E095-5JN-0066

Subject	Note on parts replacement (Change to the shape of Exit guide and Bracket)				
Model	TASKalfa 750c, TASKalfa 650c, TASKalfa 550c				
Classification	Field measure timing:	Information (including compatibility)			
	Problem:	Except SC/Error, Paper Feeding/Conveying, Image or Machine operation			
	Type of change:	Hardware

FIG. 77 RADF-FEED-6-ASM

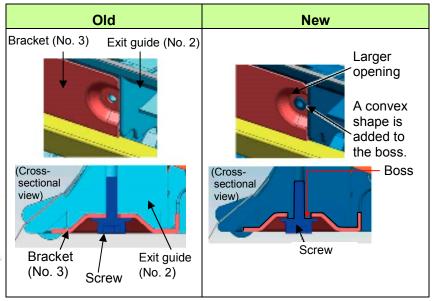
Exit guide (No. 2) and Bracket (No. 3) are changed as shown below for the assembly work efficiency purposes. A special attention is required when replacing the parts after this change, please refer to the [Field Measure].

When installing the new Bracket (No. 3) to the new Exit guide (No. 2), fit the boss on the Exit guide into the opening on the Bracket and then secure it using a screw.

Field Measure	When replacing with new Exit guide No. 2), please use a set part (No. 1). (As for installation, refer to [Installing new Bracket (No. 3)] above.)		
Implement timing	There is no current production.

^{*1:} When using the new Exit guide (No. 2), please use the new bracket (No. 3).

[Exit guide (No. 2)]

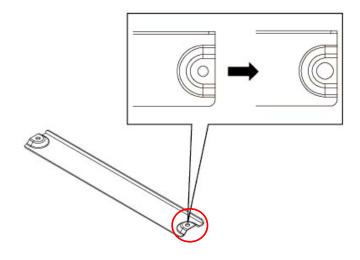
A convex shape is added to the even-shaped boss as shown.

According to the change to the Exit guide (No. 2), the opening on the Bracket is enlarged.
